Replacement of "separation baffles" and "protection bricks" in oil-firebox

Stk	Gegenstand		mrk. nr.	Tegn. nr.	materialie
	 MOOD TARM - DEVI MAHK			skala	tegn. / 1976
	<b>TARM 504</b> Replacement of "separation baffles" and "protection bricks"			(erstattung for)	122813, (ersatztel af)

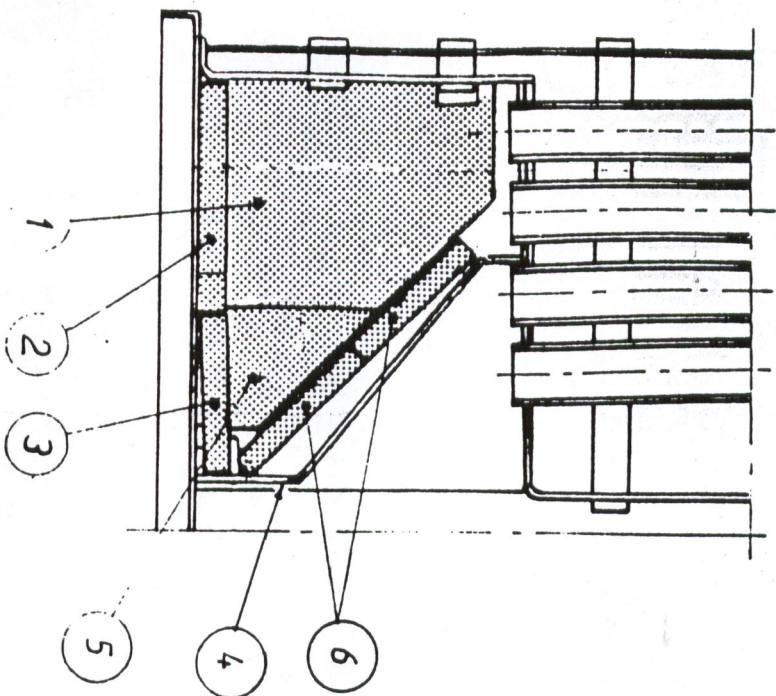
- I Remove shaker grates and the two old separation baffles (4) through the solid-fuel firebox.
- II Remove the bricks from the oil-firebox in sequence: (2) - (3) - (1)
- III Put in the new separation baffles (4) from the solid-fuel side (be careful, the plates shall fit tightly together). Assemble the shaker grates.
- IV Assemble the bricks in the oil-firebox in sequence: (6) (2 pcs. inclined, added) (5) (front - and rear firebricks, added) (3) - (1) - (2).
